**CPUC Docket:** A.23-05-010  
**Exhibit Number:** TURN-05-E  
**Witness:** Jalal Awan

**PREPARED TESTIMONY OF  
JALAL AWAN**

**ADDRESSING SOUTHERN CALIFORNIA EDISON’S TY 2025 GENERAL  
RATE CASE DISTRIBUTION RELATED ISSUES AS IDENTIFIED IN  
EXHIBIT SCE-02 (‘GRID ACTIVITIES’)**

**THE UTILITY REFORM NETWORK**

Figure 26 Regression analysis of Risk Reduction (y) as a function of Conductor Length (x)

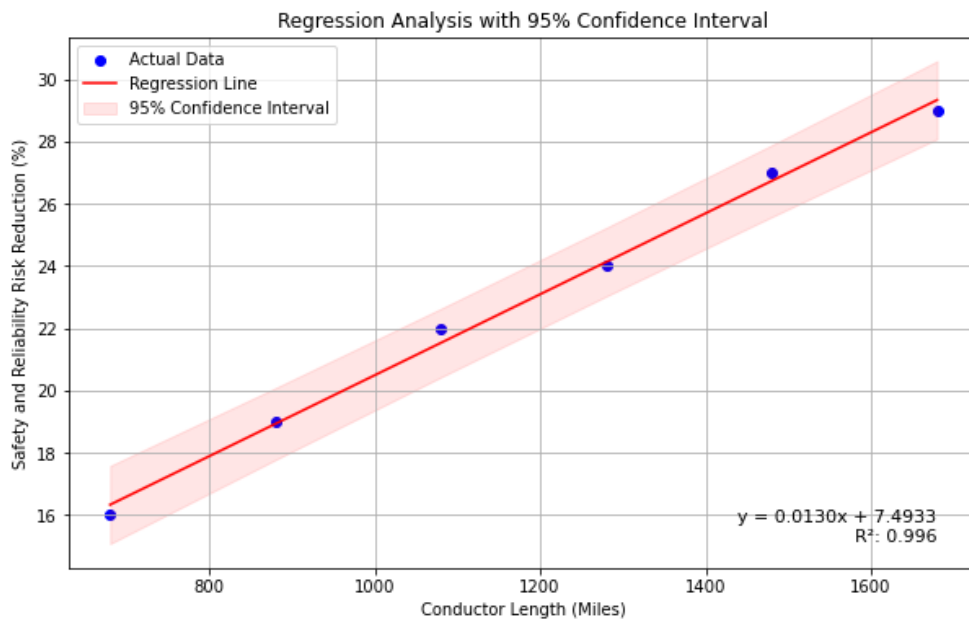
relationship exists between risk reduction and covered conductor miles. TURN notes that due to a very small dataset (n=6), the results should be interpreted with caution, despite being statistically significant. Notwithstanding this, the relationship is surprising, indicating that SCE’s risk-reduction modeling suggests near-linear risk reduction for every unit increase in covered conductor length from 680 to 1,680 miles.<sup>84</sup> In contrast, SCE’s previous modeling shows significantly diminishing returns from covered conductor in HFRAs, specifically: “SCE’s RAMP and GRC wildfire risk analyses show that the top 90% of wildfire risk in the HFTD is contained within approximately 2,200 or 1,800 circuit miles, respectively.”<sup>85</sup>

Figure 28 Percentage and Number of Cable Failures by Causes (2013-2022)

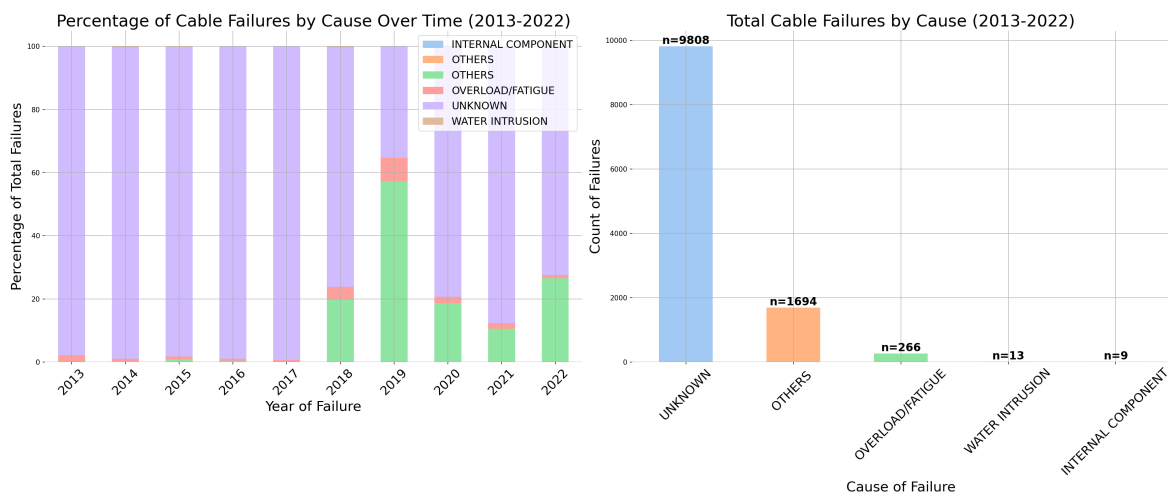
SCE’s data, as presented in the 2025 GRC, reveals an aging underground cable infrastructure with an average cable lifespan of 38 years and approximately 1,300 failures annually since 2017, attributed to a variety of causes such as equipment and component failures, cable loading, and water intrusion. Rather than the UCR program's approach of preemptively replacing 1,600 miles of cable, which somewhat overlooks the multifaceted nature of the failure causes, a more nuanced response may include conducting root cause analysis for component failures, cable loading, and water intrusion as a lower-cost alternative to wholesale replacement.

Figure 29 Safety-Reliability Risk Reduction vs. Miles of Cable Replaced

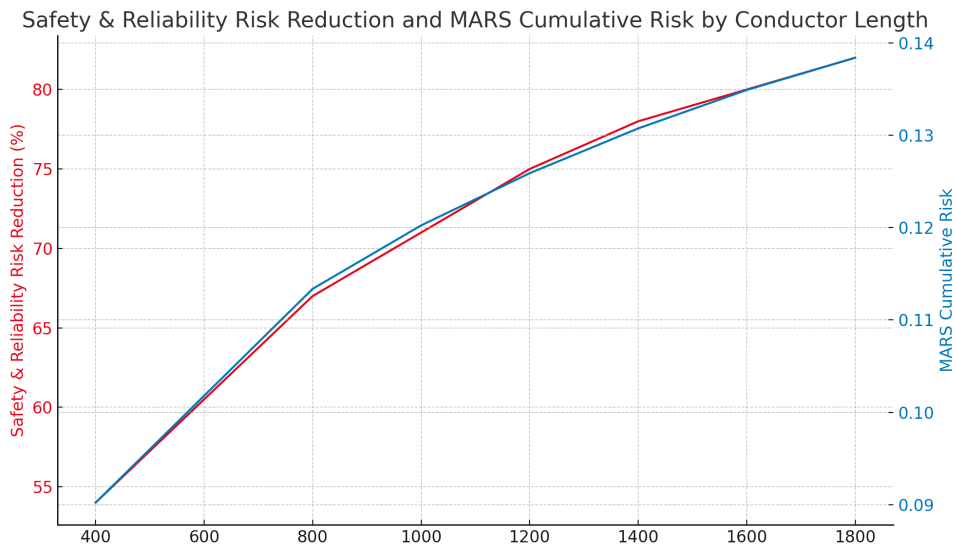
According to SCE response to PAO’s DR<sup>89</sup>, the Safety and Reliability Risk Reduction goes substantially down after the first 800 miles of replacement. The steepest safety/reliability benefit vs. miles replaced is expected for the first 800 miles of underground cable, and as shown by the concave-down curve for Safety-Reliability Risk Reduction vs. Miles of Cable Replaced, most (projected) benefits from replacement may be achieved by replacing fewer miles than SCE recommends.
